Normandy Way, Hinckley
Technical Note – Response to LCC Highways
January 2026
Our Ref: 29480-TRAN-0802 – Revision A

LCC Highways Comments / MEC Response

Table 1: LCC comments (July 2025) / MEC response

Table 2: LCC comments (December 2025) / MEC response

APPENDICES
Appendix H

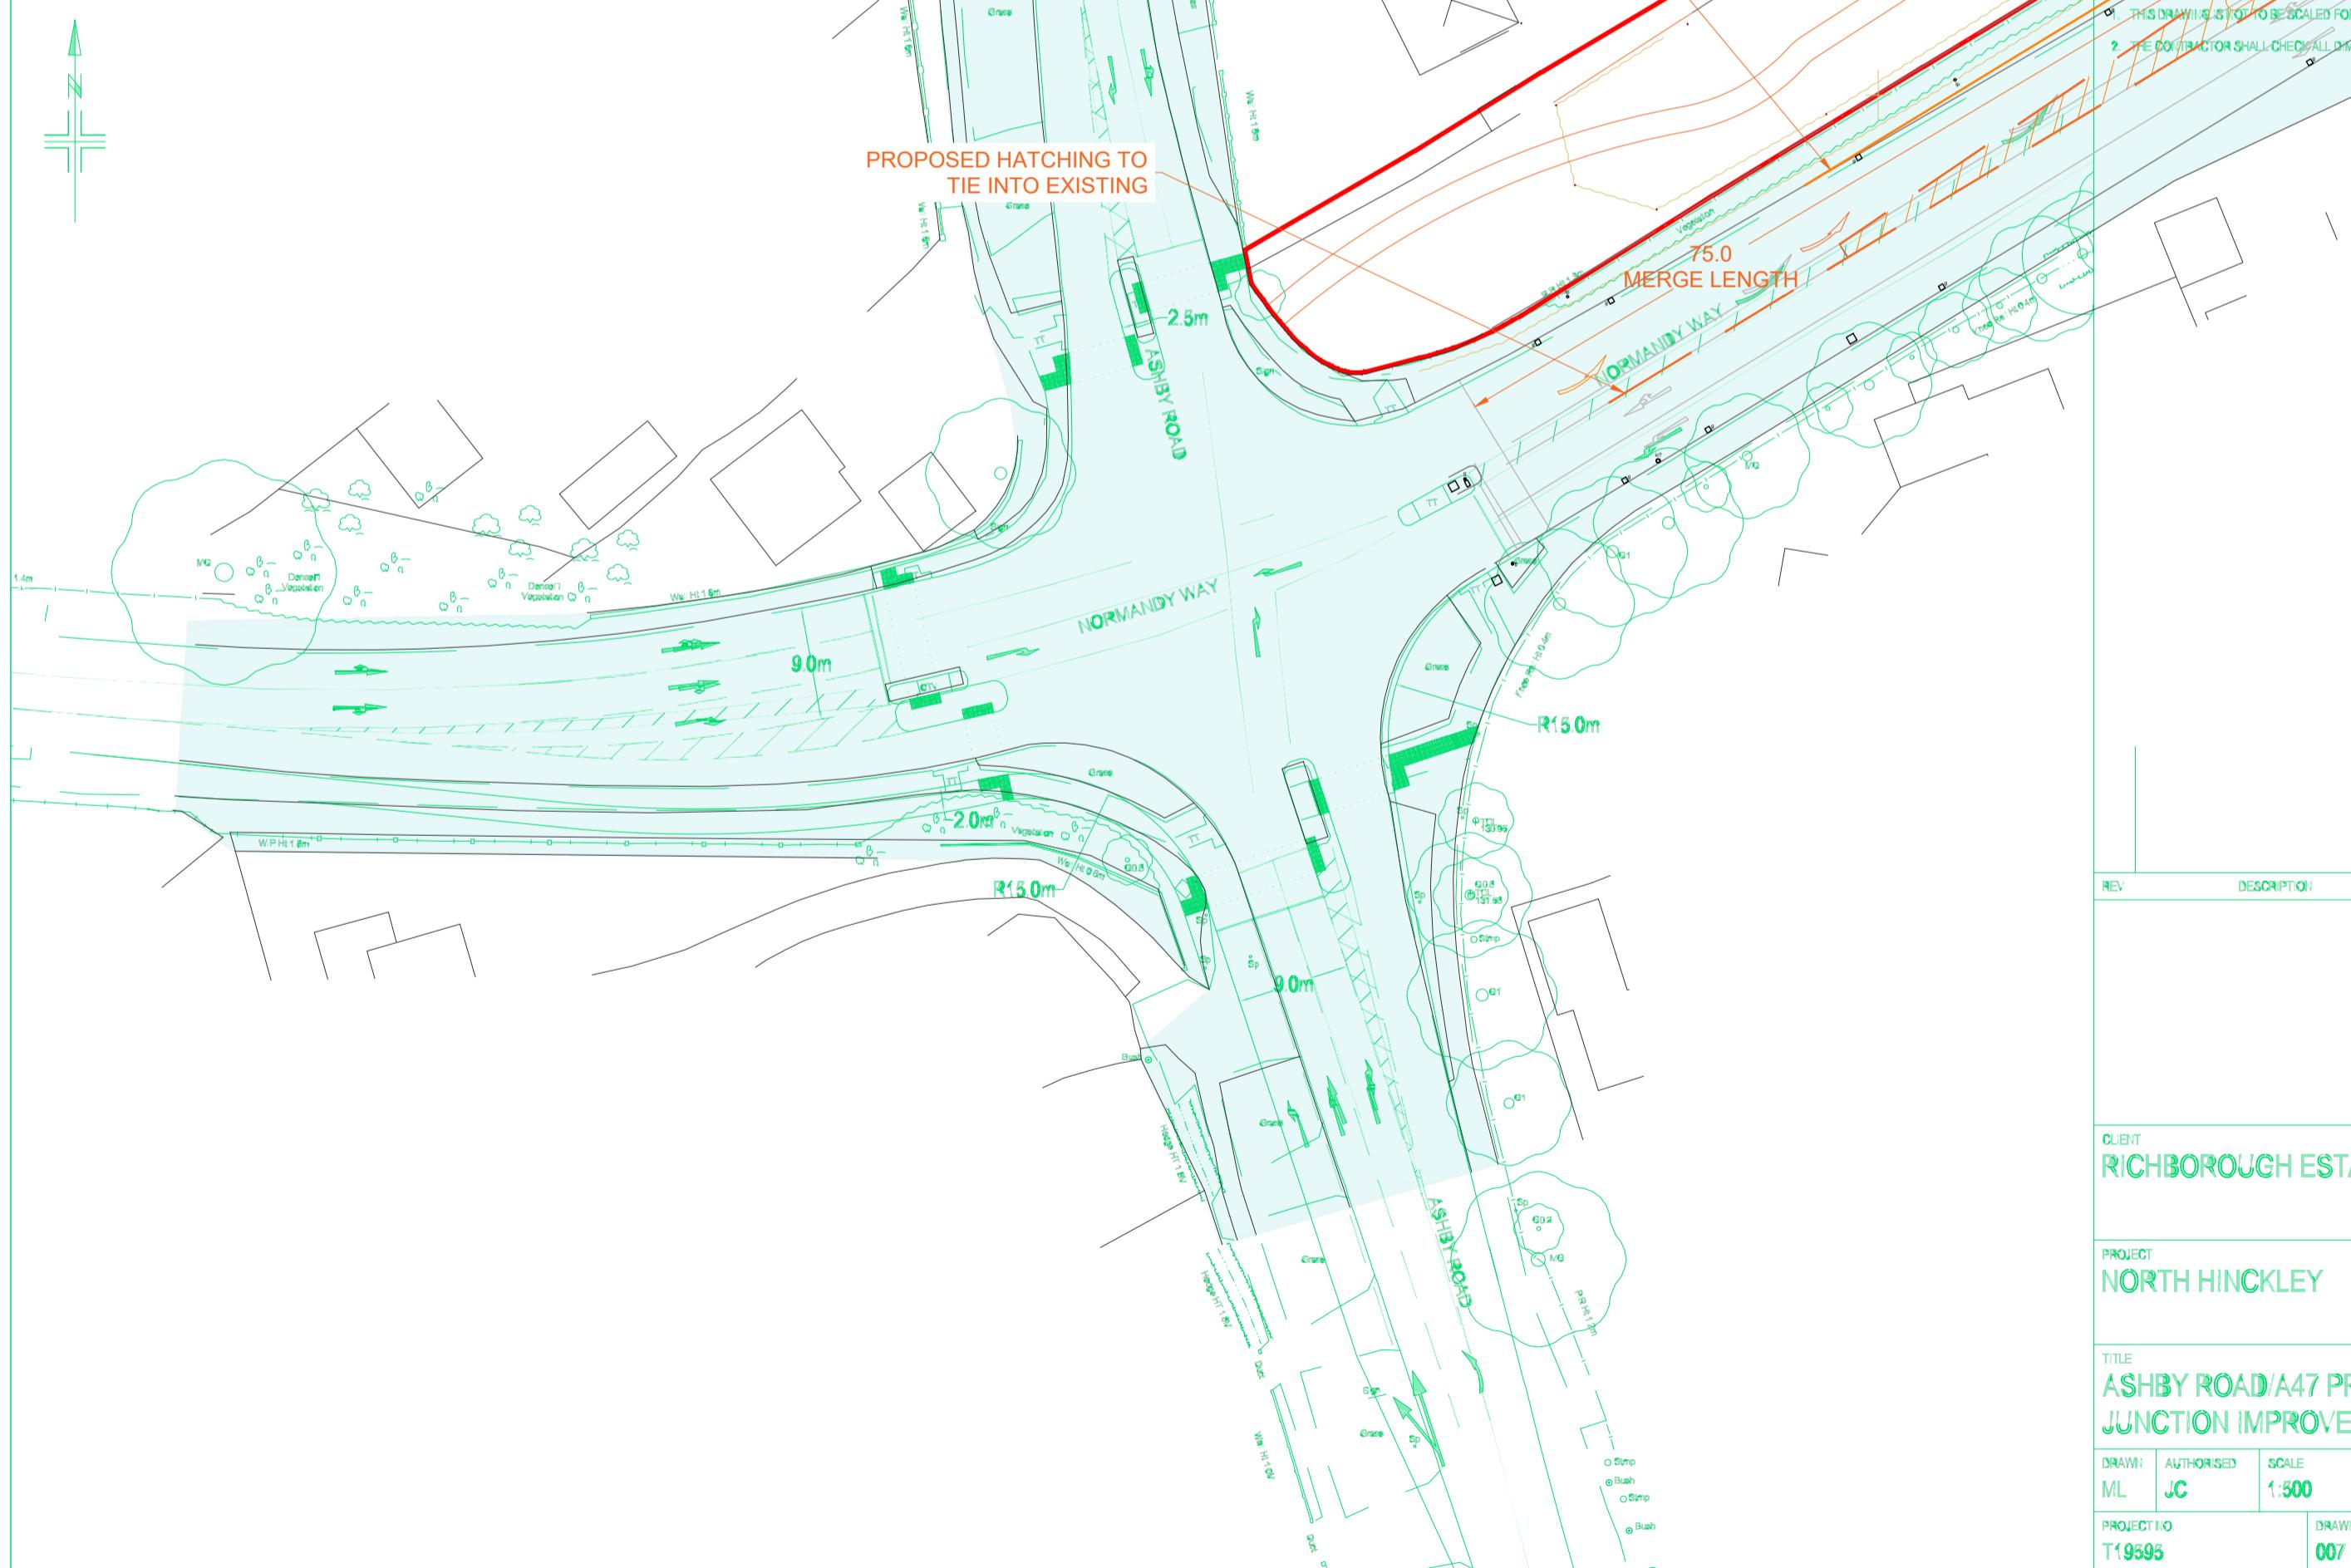
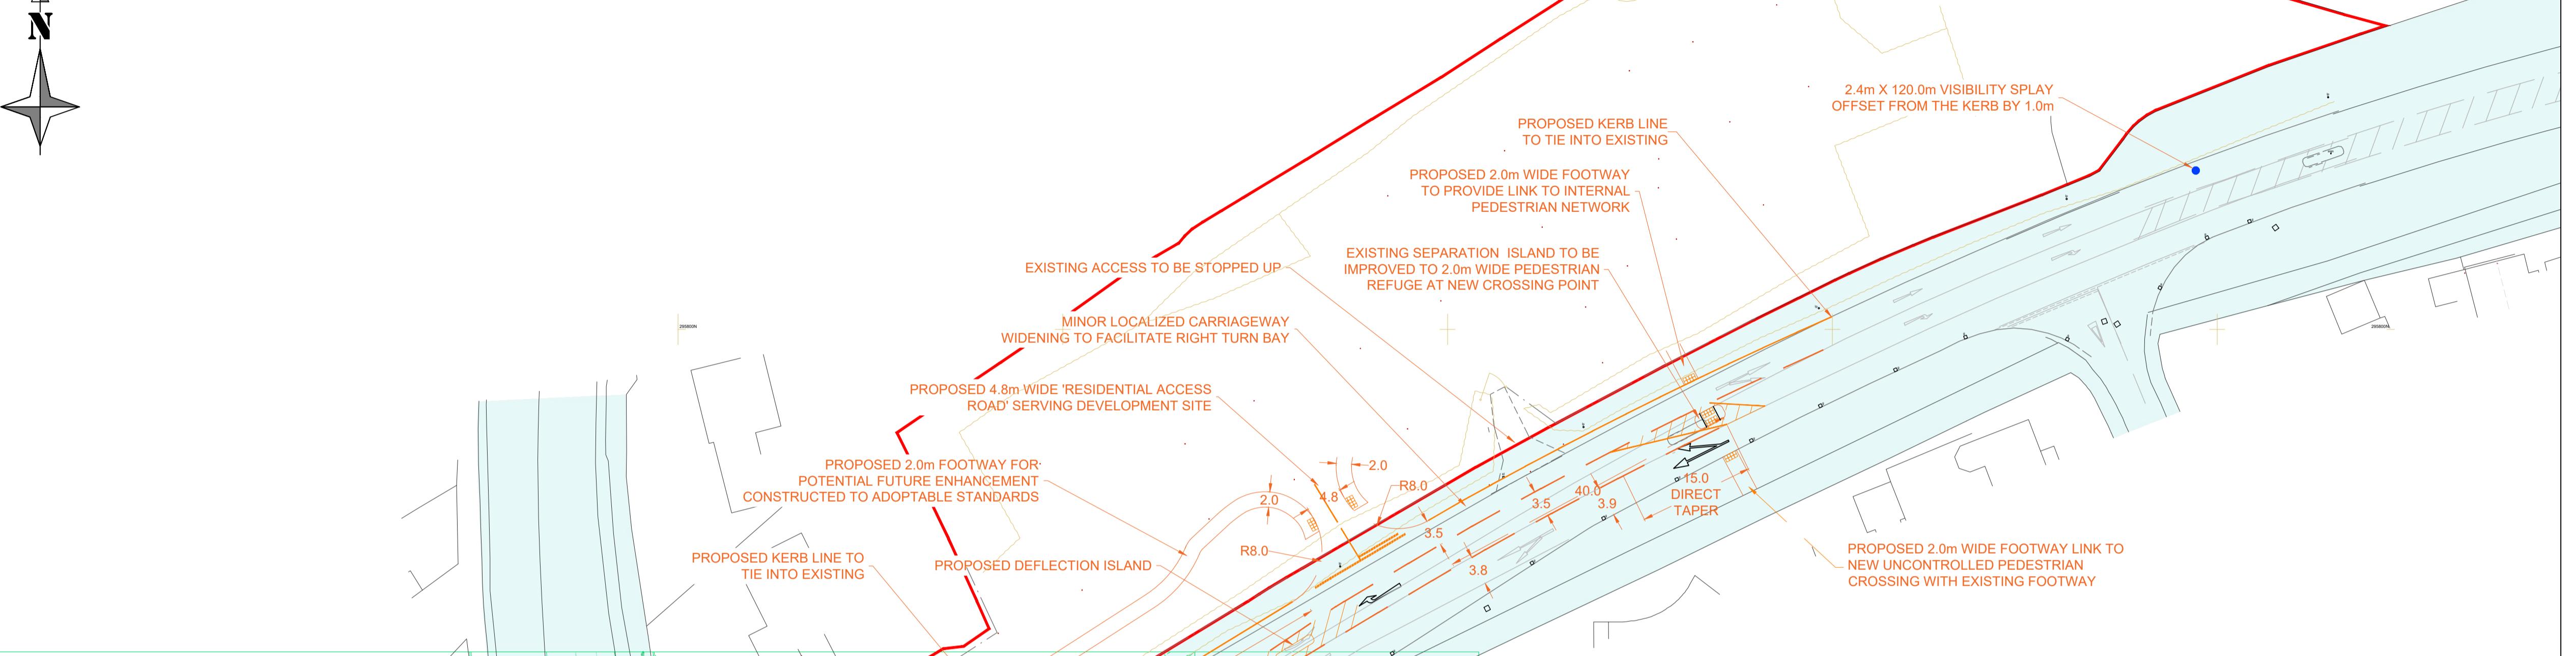
LCC comments:	MEC response:
<p>1 "The LHA advised as part of application reference 22/00318/OUT, Condition 30 of the appeal decision (Appeal Ref: APP/K2420/W/23/3323113) required either "the offsite works shown on Dwg No T19595-007 Rev C Ashby Rd/A47 (Proposed Junction Improvements) to have been implemented in full, or an alternative scheme that mitigates the impacts of the development has been submitted to and approved in writing by the local planning authority and thereafter implemented in accordance with the approved scheme".</p> <p>Currently an alternative scheme is being investigated by Leicestershire County Council to accommodate the wider growth in the area, however the LHA advises the proposed development access could prejudice the delivery of either scheme, given the proximity of the site access to the existing junction and the requirement to reduce the length of the</p>	<p>MEC has reviewed the most recent response provided by LCC highways in December 2025 (reference 2025/4964/04/P/HEN), and set out its comments below for consideration by both the LHA and the LPA.</p> <p>We consider that:</p> <ul style="list-style-type: none"> • Insufficient evidence has been provided by LCC Highways to demonstrate that the development proposals would lead to a severe residual, cumulative impact in capacity terms. The NPPF (December 2024) states in paragraph 116 that: <p><i>"Development should only be prevented or refused on highways grounds if there would be an unacceptable impact on highway safety, or the residual cumulative impacts on the road network, following mitigation, would be severe, taking into</i></p>

LCC comments:	MEC response:
<p><i>merging lane, which the LHA do not wish to see reduced given existing capacity concerns.</i></p> <p><i>The LHA cannot see any reasonable way to resolve this concern as the site access could not be relocated further west towards the signalised junction and to relocate it further east would impact on the existing ghost right turn lane for the existing Cornwall Way estate.”</i></p>	<p><i>account all reasonable future scenarios.”</i></p> <p>This relates to the operation of the A47 Normandy Way / Ashby Road junction as improved by the committed improvement secured by the LPA against the Richborough Estates development (Condition 30 of appeal reference APP/K2420/W/23/3323113, Drawing No. T19595-007 Rev C Ashby Rd / A47) – and – on the basis that the ‘alternative scheme’ being investigated by the LHA for the junction has not been shared publicly, has no planning status and should not therefore be used as a basis for non-determination or objection to the proposals. Drawing No. T19595-007 Rev C Ashby Rd A47 is included for reference in Appendix F.</p> <p>Further review has been undertaken in this Technical Note demonstrating the following:</p> <ul style="list-style-type: none"> - The proposed access arrangements to the site would not affect the Richborough Estates’ scheme on the northern, western and southern arms of the A47 Normandy Way junction, as shown on MEC Drawing No. 29480_08_020_03 in Appendix G; and - No evidence has been provided by the LHA demonstrating the proposed 25m-length reduction in the A47 Normandy Way eastbound exit merge would generate a severe residual, cumulative impact on the operation of the junction in capacity terms. The LPA and LHA are also reminded that the increase in traffic from 25 No. dwellings would be unlikely to generate a severe impact either in capacity terms. <ul style="list-style-type: none"> • No acknowledgement continues to be given to the LPA in LCC’s response to the highway safety benefits of the development proposals in providing: <ul style="list-style-type: none"> - An uncontrolled crossing facility of the A47 Normandy Way for pedestrians which, based on site observations, is not currently the case and given allotments users currently park in nearby residential streets and cross on the desire line south of Cornwall Way; and - A dedicated right-turn facility into the site off the A47 Normandy Way, which will reduce the blocking effects on westbound ahead movements to the A47 Normandy Way / Ashby Road junction.

- The proposed access arrangements to the site would not affect the northern, southern and western side of a committed highway improvement scheme by Richborough Estates for the A47 / Ashby Road signalised junction, and insufficient evidence has been provided by LCC highways to the local planning authority in supports of its assertions the development would impact LCC's 'alternative scheme' for the junction;
- The development is considered to be very well located to promote trips by sustainable modes of transport, being located adjacent to existing residential development, public transport routes and local amenities as per the March 2025 Transport Statement; and
- An increase in traffic movements of 12 and 10 No. two-way trips during the weekday AM 0800-0900 and PM 1700-1800 periods is unlikely to have severe impact in accordance with the NPPF on the operation of the local road network.
